Access Compliance Report

Public Rights-of-Way

(Curb Ramps)

Intersection ID: 18726	Main Street: TYVOLA_RD	Cross Street: OLD_PINEVILLE_RD	Location: SE
ADA ID: 7916C329250A	Ramp Type: Perp	Initial Pass/Fail: Fail	Overall Compliance: No
Severity Score: 8.75			
Codes/Mitigation Info/Possible Solution		Field Measurements/Component Compliance

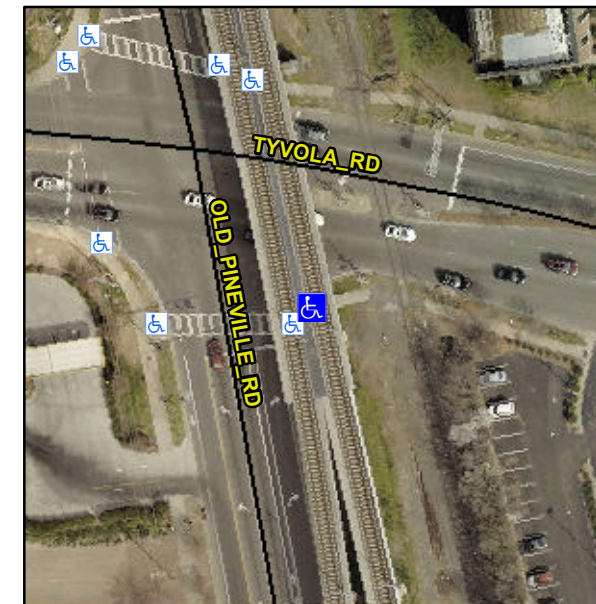
Not Found, R304.5.1

Compliance	Description	Data	Compliance	Description	Data
N/A	Ramp Length (in)	137.0	Yes	Ramp Slope (%)	6.5
No	Ramp Width (in)	47.0	Yes	Ramp XSlope (%)	2.0
N/A	Flare Type LT	N/A	N/A	Flare Type RT	N/A
N/A	Flare Slope LT (%)	N/A	N/A	Flare Slope RT (%)	N/A
N/A	Flare Traversable LT?	N/A	N/A	Flare Traversable RT?	N/A
N/A	Landing Length (in)	N/A	N/A	DWS Provided?	N/A
N/A	Landing Width (in)	N/A	N/A	DWS Contrast?	N/A
N/A	Landing Slope (%)	N/A	N/A	DWS Length (in)	N/A
N/A	Landing X Slope (%)	N/A	N/A	DWS Full Width?	N/A
N/A	Landing Curb? (Y/N)	N/A	N/A	DWS Offset (in)	N/A
N/A	Shared Landing?	N/A			
N/A	Gutter Ponding?	N/A	N/A	Gutter Slope (%)	N/A
N/A	Gutter Lip Ht (in)	N/A	N/A	Gutter X Slope (%)	N/A
N/A	Painted X Walk1?	Yes	N/A	Painted X Walk2?	N/A
	X Walk 1 Direction	To N		X Walk 2 Direction	N/A
N/A	X Walk 1 Width (in)	105.0	N/A	X Walk 2 Width (in)	N/A
	X Walk 1 Slope (%)	1.6		X Walk 2 Slope (%)	N/A
	X Walk 1 X Slope (%)	0.6		X Walk 2 X Slope (%)	N/A

Remove & Replace Entire Ramp.
